NARRATIVE DESCRIPTION OF ALTERNATIVE 7-HYBRID PLAN HOUSING CONCEPT SITE PLAN AND LANDSCAPE CONCEPT PLAN

ALTERNATIVE 7-HYBRID PLAN REVISIONS SINCE 6 AUGUST 2020

TIOGA INN

LANDSCAPE CONCEPT PLAN

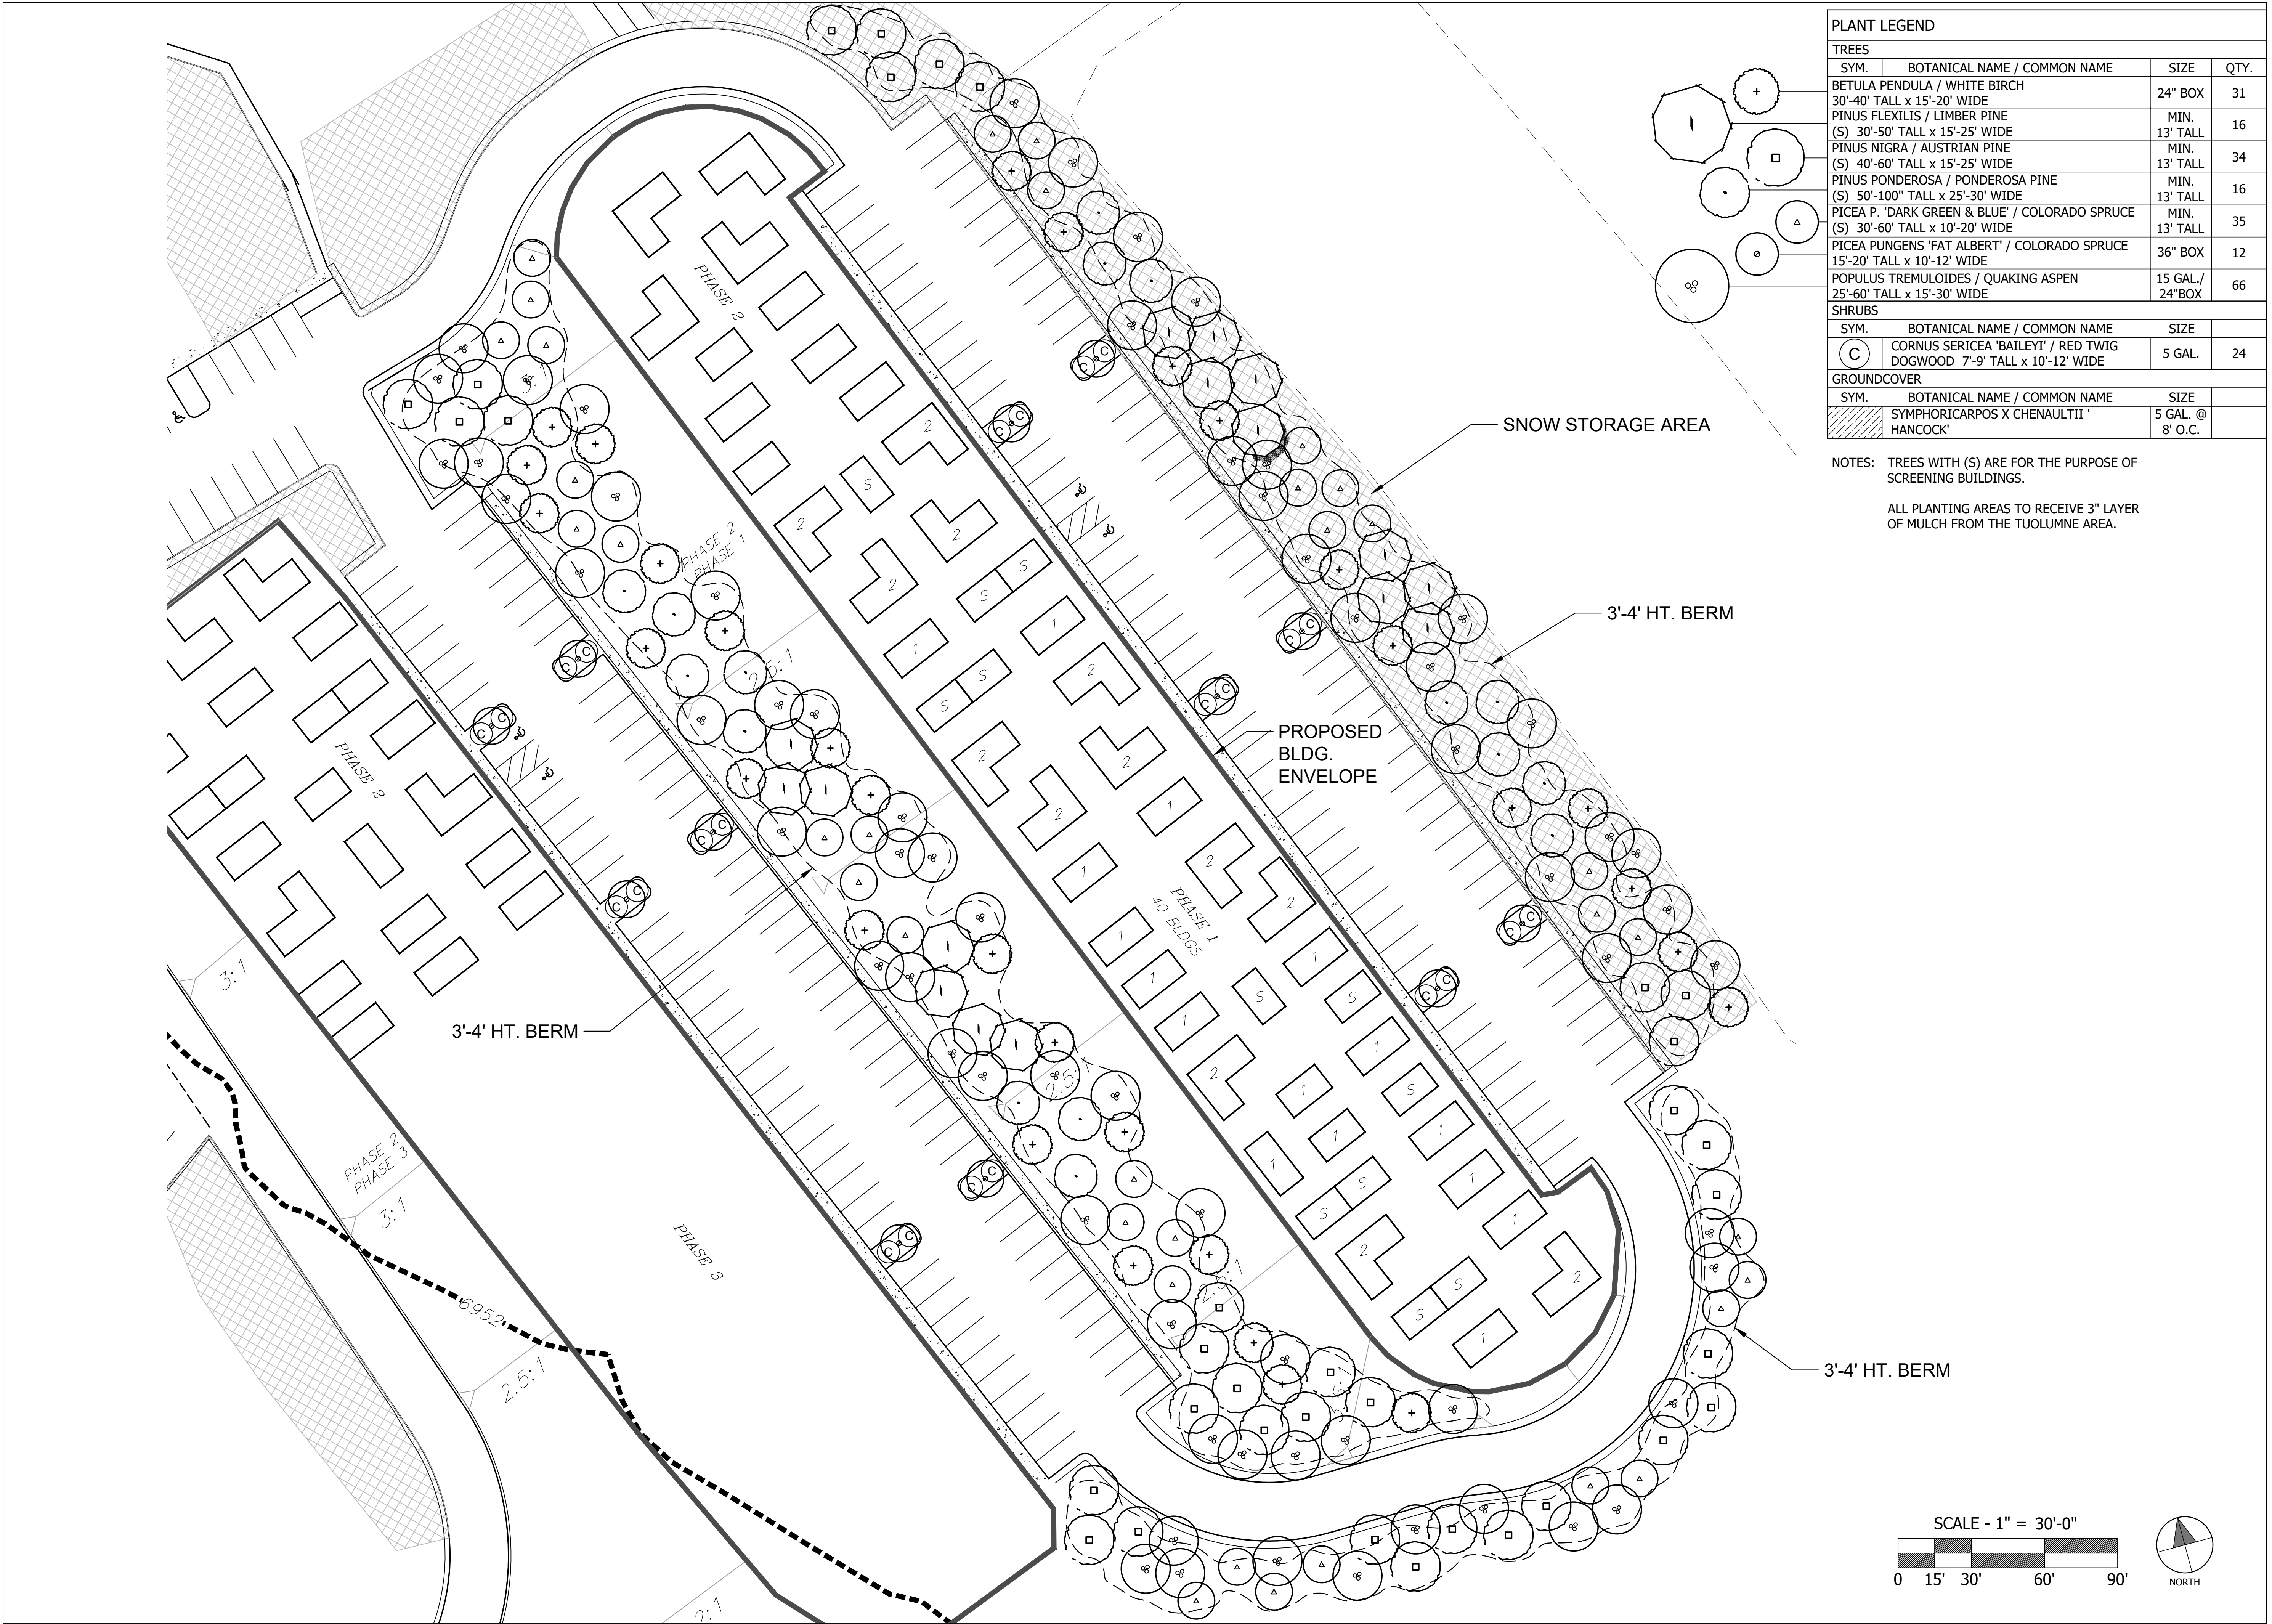
The August 2020 Board packet of materials included a Screening Tree Plan that had been prepared by Triad Holmes & Associates and has now been refined by Weiland Design Group into the Landscape Concept Plan (Attachment 4). In preparing this Plan, Bob Weiland of Weiland Design Group, Inc., visited offsite locations including South Tufa, Navy Beach, and US 395 to ensure the landscape design would specifically screen structures from these viewpoints.

The Landscape Concept Plan consists of seven tree species, one shrub and one groundcover species. Four of the seven tree species will be a minimum height of 13-feet at the time of planting on top of the three-to-four-foot parking lot berm (for a total initial tree height of at least 16 feet) to provide effective screening at the outset, and two of the species would be planted in 24" boxes. All boxed tree species would be purchased one year in advance of planting to allow the root systems a full year to become established prior to planting. Mitigation measure 5.12(a,b-2)(Visual Screening & Landscaping) below provides for the timing, monitoring, and performance of the landscaping to ensure compliance with the CEQA visual analysis:

To create a more natural appearance from offsite vantage points, the landscaped berms below each of the two main parking lots, which will also prevent vehicle headlights from shining across the Mono Basin, will have undulating widths and variable heights ranging between three to four feet, as shown on the Landscape Concept Plan. In combination, the landscape trees and berm will provide effective screening from South Tufa, Navy Beach, and US 395 from the initial development phases throughout the life of the proposed Community Housing Project.

MITIGATION MEASURE 5.12(a,b-2)(Visual Screening & Landscaping): All landscaping shall be planted consistent with the Alternative 7 Landscape Concept Plan as soon as site grading is complete. A landscaping or restoration specialist approved by the County shall monitor tree health, screening efficacy and replacement requirements for the first 5-years of growth. The landscape/restoration specialist shall have authority to replace plantings as needed to attain within five years a goal of providing at minimum the number of trees shown on the Landscape Concept Plan. If monitoring by the 5th year indicates that the visual analysis expectation has not been met to screen the structure walls, windows and roof from offsite locations, additional plantings will be added and annual monitoring will continue every year until the screening goal has been met.
